Reliability Analysis Update

Transmission Expansion Advisory
Committee

January 10, 2019

Dominion/PEPCO B2443 – Glebe to Station C Project Update

Dominion Transmission Zone: Baseline Glebe – Station C Project

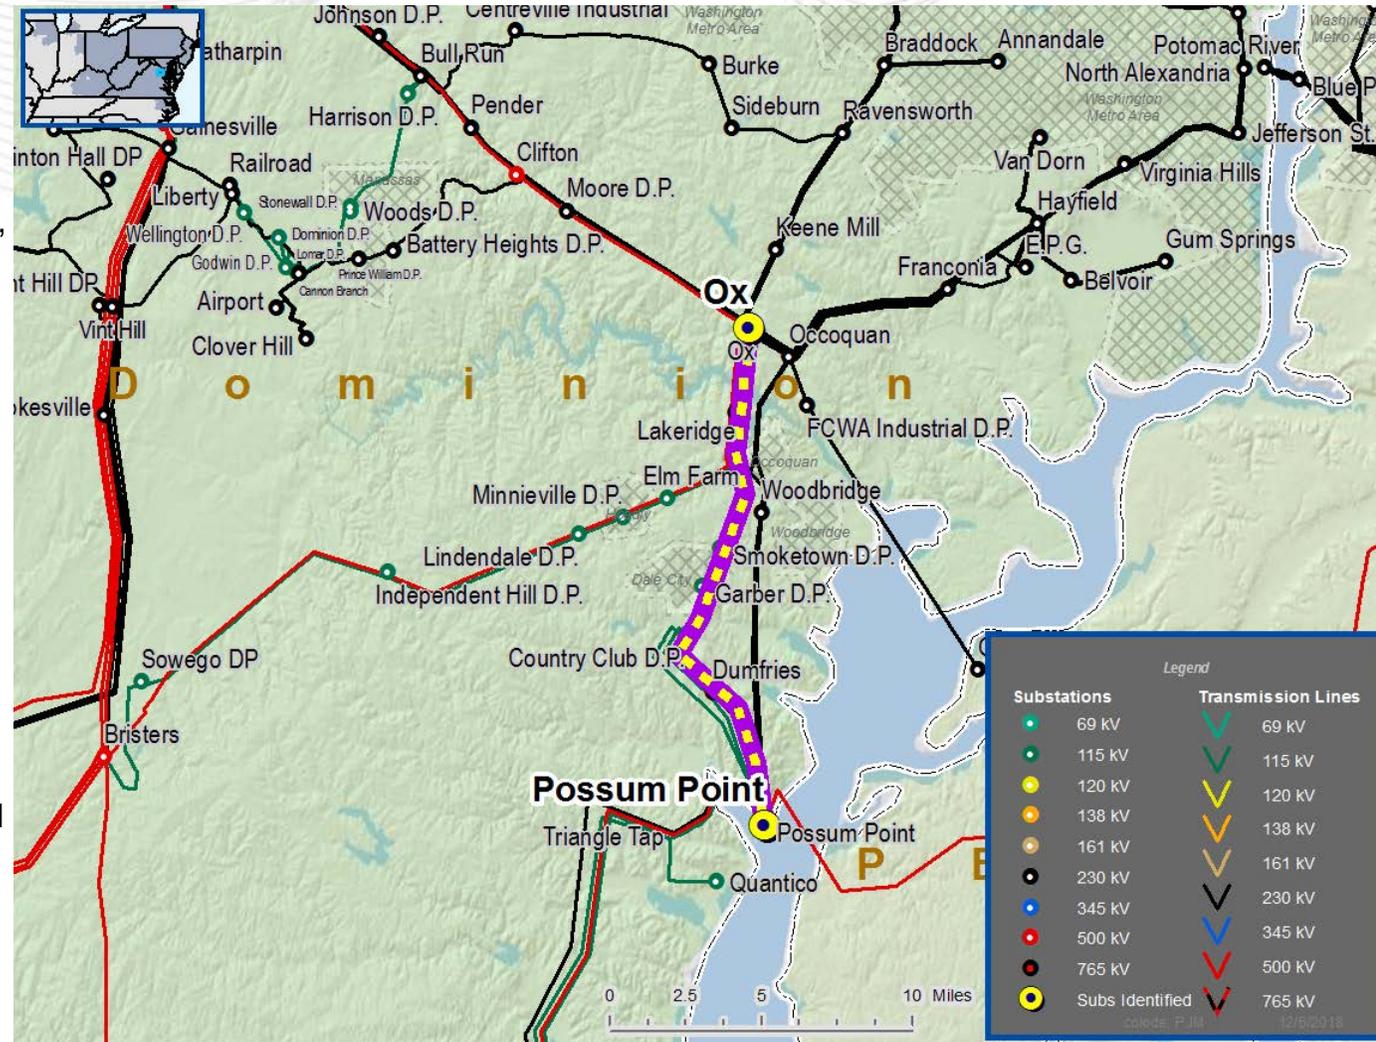
Problem Statement: Updated NERC Reliability Drivers

- Original criteria violations included overloads of Ox 500/230 kV Tx #1 & #2, 230 kV Line #248 (UG section between Carlyle South – North Potomac Yard) and the Franconia – Van Dorn Section of 230 kV Line #243.

- Updated criteria violation – Based on recent generation retirements (Possum Point Units #3 & #4) and the PJM 2018 Load Forecast updates indicates that for a NERC Category P1 – single contingency that Possum Point 500/230 kV Tx #1 overloads for a loss of the Possum Point – Ox 500 kV Line #571 under Dominion’s critical stress case criteria.

- Other previously identified deficiencies in Dominion and PEPCO are no longer present.
- The Glebe – Station C Project (b2443) will be cancelled and replaced with a new baseline to resolve the NERC reliability deficiencies.

- The previously approved cost for the Glebe – Station C Project: **\$299 M**
 - The new baseline will be discussed on the next slide.
